PLANNING APPEAL STATEMENT

“Demolition of an existing 2-bed bungalow and erection of a new 4-bedroom bungalow with habitable roof space, including side dormer, raising the ridge of the main roof, roof lights and solar panels.”

Site Address: 14 Larne Road, HA4 8DR, Ruislip, Hillingdon, Middlesex

Planning Application Reference: 57311/APP/2022/3104

Image 2- Loft Plan submitted as part of 57311/APP/2022/3104 (2022)

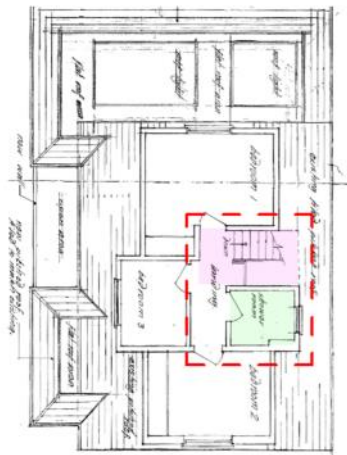
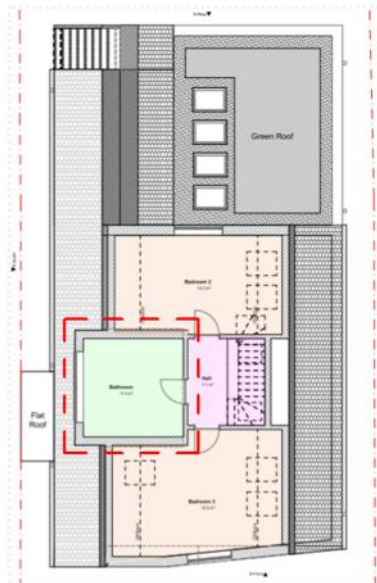
The proposed development is for a single storey, 4-bedroom, detached house with habitable roof space. Within the loft area - two bedrooms and a family bathroom have been proposed. However, despite clear labelling of rooms, submitted floor plans have been interpreted incorrectly by the council.

Proposed BATHROOM has been misread as an additional BEDROOM. This misinterpretation grounds a foundation for refusal Reason 2 and refusal Reason 3.

Reason 2 & 3 are based on a clear mistake as within the Officers Report under paragraph 7.5 Urban Design, Access and Security Considerations – Internal amenity Space Provision - council representative points correctly that there are four bedrooms within the house, out of which three are labelled as 'Bedroom' and one as an 'Office' which in total gives 4 Bedroom house (as applied for within the application submitted).

Within the same paragraph a reference to a fifth 'bedroom' suddenly appears. This reference is incorrect as this room is labelled as Bathroom.

Moreover, it has been described that this Bathroom/'Room in question' is overlooking neighbouring properties' habitable room (also described as bedroom). This statement is again incorrect. The room behind No.16's dormer window is a shower room with an adjacent staircase - not a bedroom. (See Image 1,2 and 3 below for reference – with Bedrooms and Bathrooms marked for clarity).

Therefore, there is no overlooking issue between habitable rooms, between existing property at No.16 and proposed house at No.14. (Reason 2)

Also, as the 'room in question' is not a bedroom but a bathroom – means there is no substandard living issue for future occupiers of no.14. (Reason 3)

Image 3- Front Elevation - Proposed

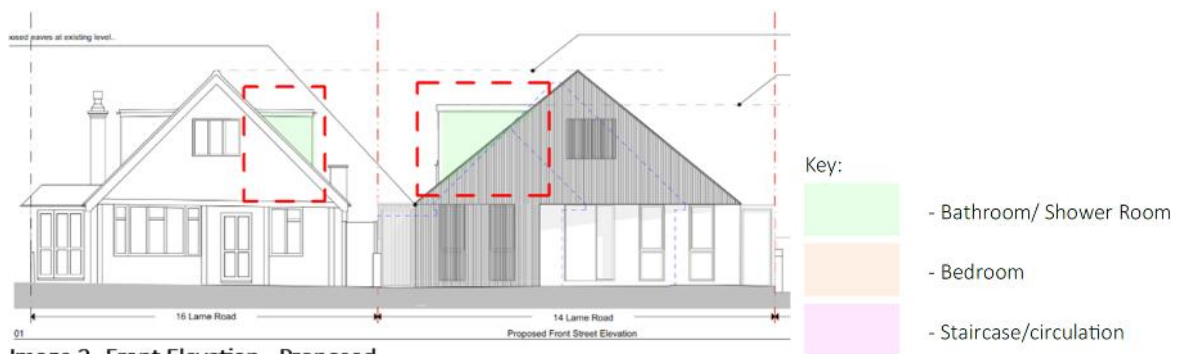
Reason 1 *“The proposed development, by virtue of its external timber cladding finish, uncharacteristic front angled wall, various roof profiles and solar panels, would fail to harmonise with the character and architectural composition of the surrounding properties, appearing as a visually obtrusive and incongruous form of development which would be detrimental to the visual amenity of the street scene and harmful to the character and appearance of the surrounding area. The proposal therefore conflicts with Policy BE1 of the Hillingdon Local Plan: Part One- Strategic Policies (2012), Policies DMHB 11 and DMHB 12 of the Hillingdon Local Plan: Part 2 - Development Management Policies (2020), Policy D4 of the London Plan (2021) and the National Planning Policy Framework (2021).”*

The reason for refusal set out in the council's decision notice refers to front elevation design and suggests it does not comply with council's policies promoting high quality design and architecture and is harmful to the character and appearance of the surrounding area.

Proposed design follows this pattern. Ground floor receives a bay window footprint with stepped back entrance & office area. First floor front wall projects above the entrance/office area in a similar manner to other properties along the street. It has been angled to further highlight the bay window zone at first floor level and to form a natural transition between no.16 and no.12. At the same time adding architectural interest to the front façade form. The design of the building is very simple in its composition.

White render and black timber cladding are being proposed to front and rear elevations of the property. Black stained or charcoal timber is a façade material commonly used across Ruislip area.

- Elevation - Timber cladding and angled wall have been removed from the front façade. Simple white render and black timber frame has been proposed to match existing buildings.
- Solar Panels have been removed from the front roof plane and skylights proposed to one side of the roof only.
- Dormer bathroom – size of a high-level dormer window has been reduced. To maintain lighting levels, a skylight has been introduced within dormer roof.
- During planning dialog that has been established during second application a further design change has been made and a GF side 'element' has been removed.
